## DEVIATION REQUEST AND DECISION FORM

Project Name : Monument Ridge East

Deviation No. 2 (Rev 10-4-2024) A deviation from the standards of or in Sections 2.2.4.A.4 and 2.3.2 of the Engineering Criteria Manual (ECM) is requested.

Deviation No. 2 - Exhibit 1

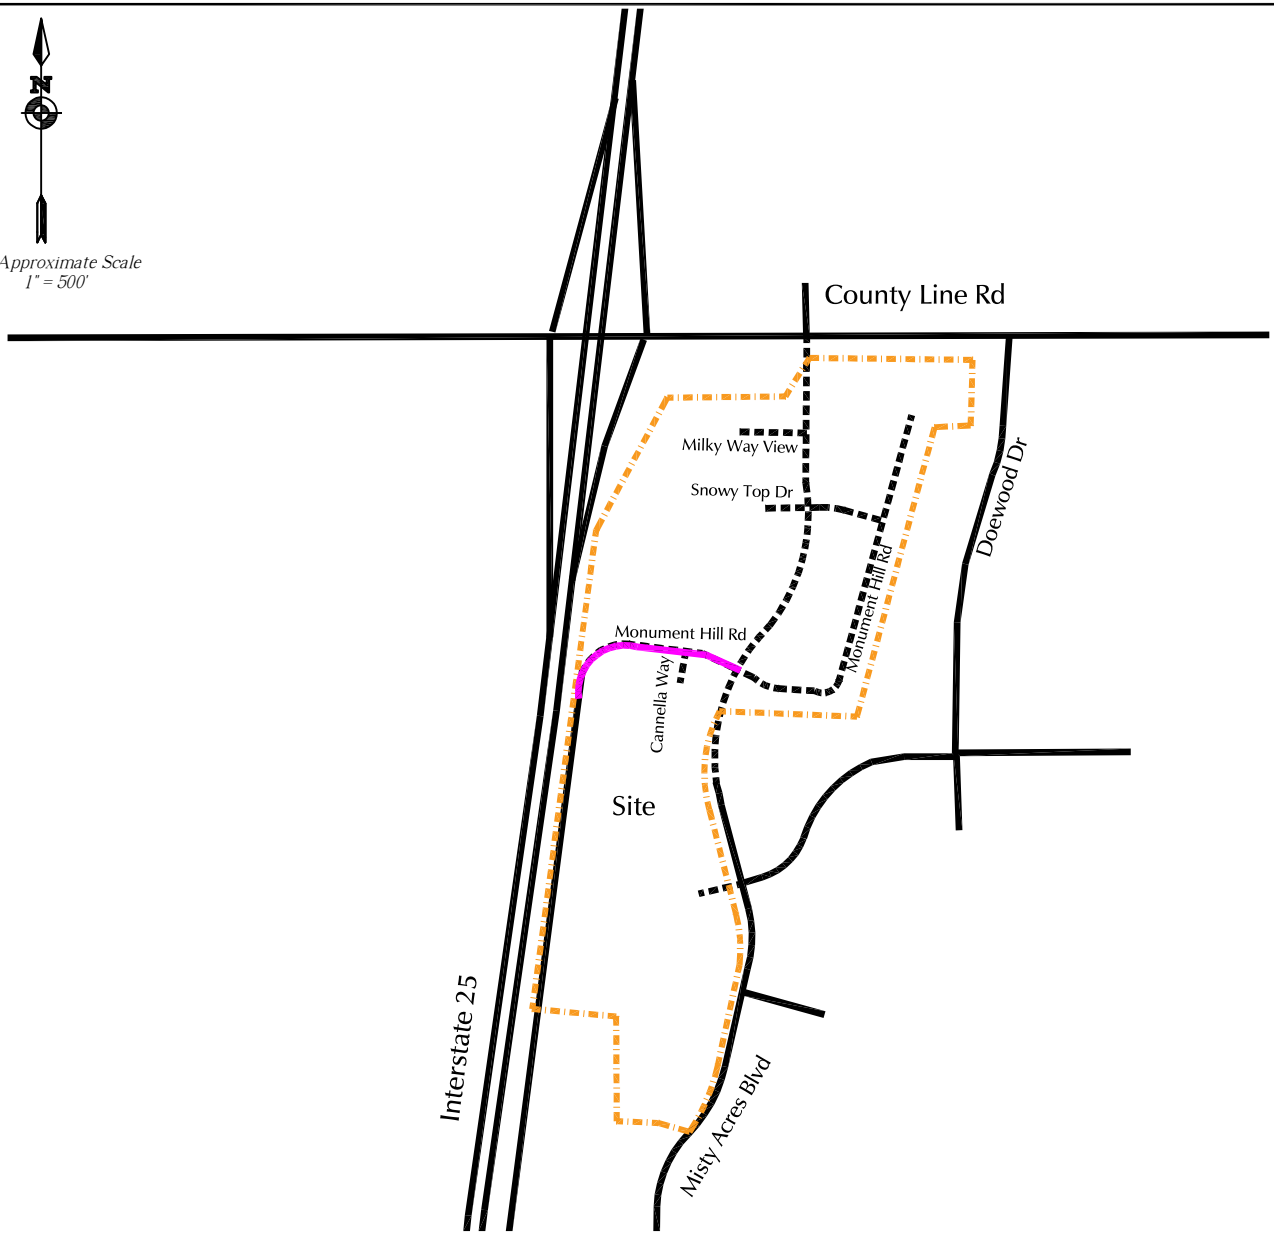
Deviation Request from ECM 2.2.4.A.4 and 2.3.2 --  
Design Standards by Function Classification

Criteria	ECM Standard for a Rural Major Collector	Proposed Design	Meets Standard for:
Design Speed	50 mph	25 mph	Urban Local
Posted Speed	45 mph	25 mph	Urban Local
Clear Zone	20'	12'	Urban Local
Minimum Centerline Radius	930'	200'	Urban Local
Number of Through Lanes	2	2	Urban Collector
Lane Width	12'	12'	Urban Collector
Right-of-way	90'	50'	Urban Local*
Paved Width	32'	30'	Urban Local
Median Width	N/A	N/A	Urban Collector
Outside Shoulder Width	8'	3'	Urban Local (N/A)
Inside Shoulder Width	N/A	N/A	Urban Local
Curb/Gutter Type	N/A	6" vertical	Urban Collector
Sidewalk Width	N/A	5' attached	Urban Local
Design ADT	3,000	3,000	Urban Local
Design Vehicle	WB-67	WB-67	Urban Collector
Bike Lanes Permitted	No	No	Urban Local
Access Permitted	No	Yes, but a private local street only, not individual lot driveways	Urban Local
Access Spacing	N/A	N/A	N/A
Intersection Spacing	1/4 mile	285' (200' required per ECM 2.2.5.E)	Urban Local

This request has been determined to have met the criteria for approval. A deviation from Section 2.2.4.A.4, 2.3.2 of the ECM is hereby granted based on the justification provided.

Deviation No. 2 - Exhibit 2  
**Proposed Realignment  
of Monument Hill Rd  
and Extension of  
Misty Acres Blvd**

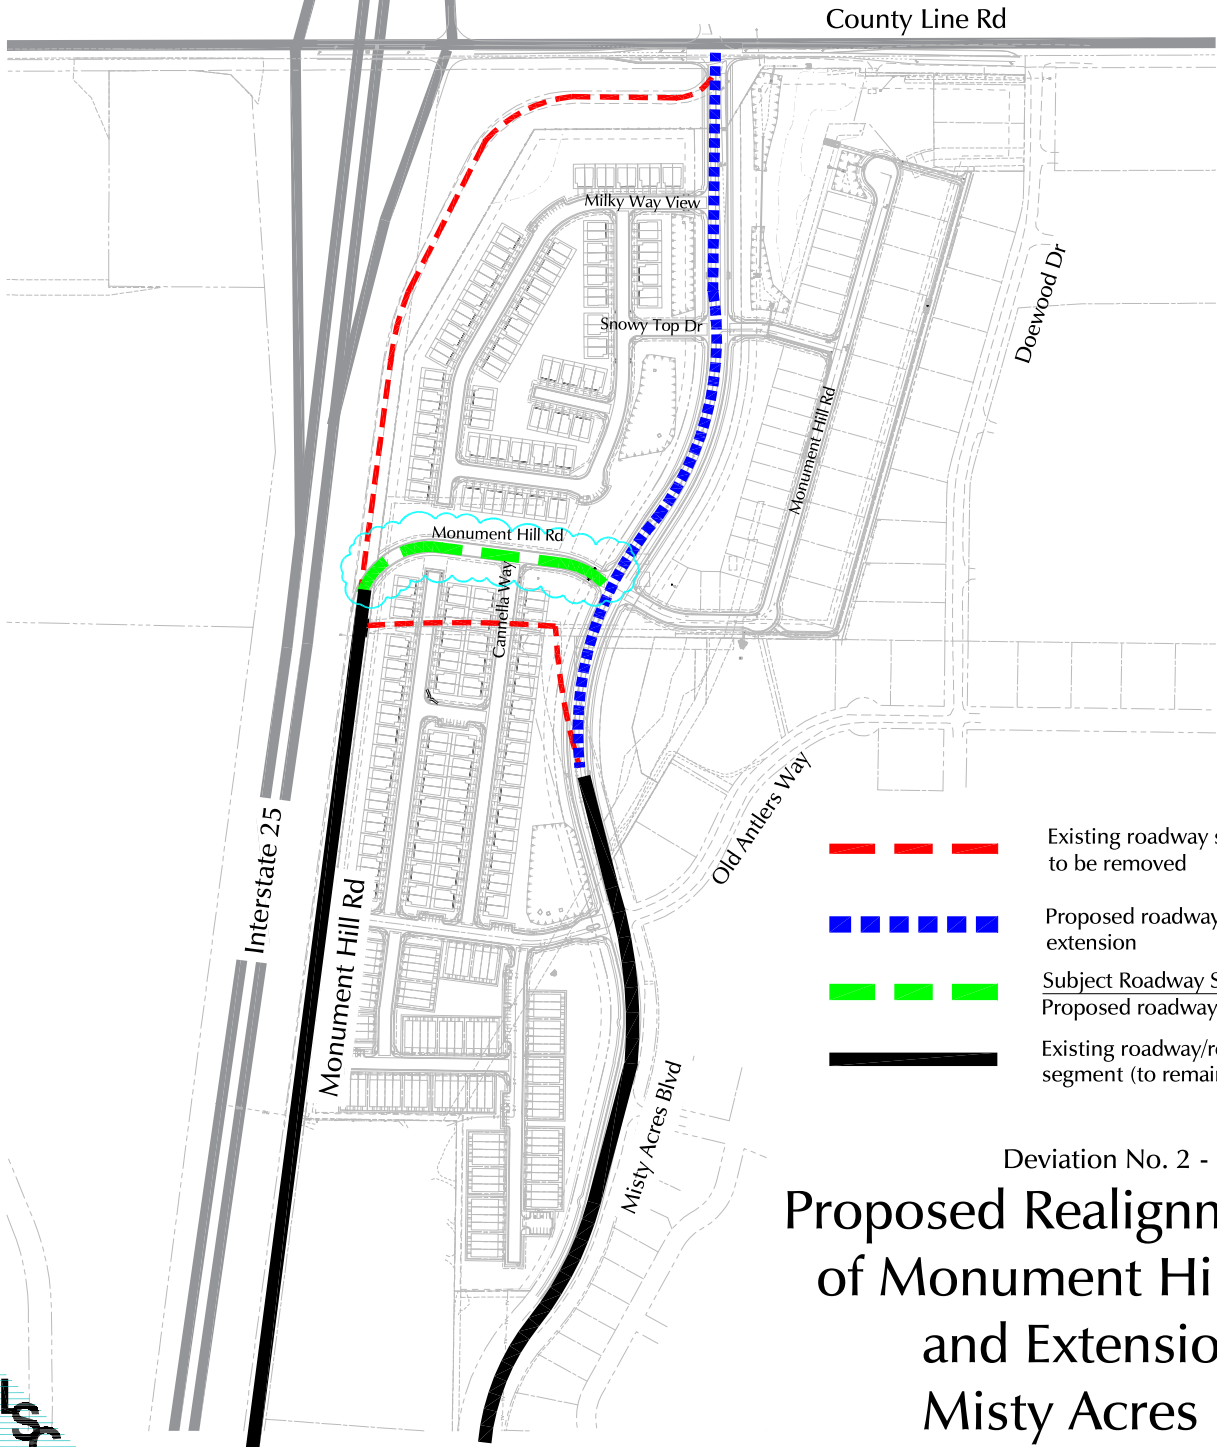
A new east-to-west segment of Monument Hill Road is proposed to connect with Misty Acres Boulevard. South of the point of curvature on this segment, Monument Hill Road would be classified as a Rural Major Collector. However, this proposed 787-foot east-to-west segment would contain design elements typically found on Urban Local roadways, primarily, but with some consistent with Urban Residential Collector roadways (notably Collector - such as no parking and no direct lot access driveways).
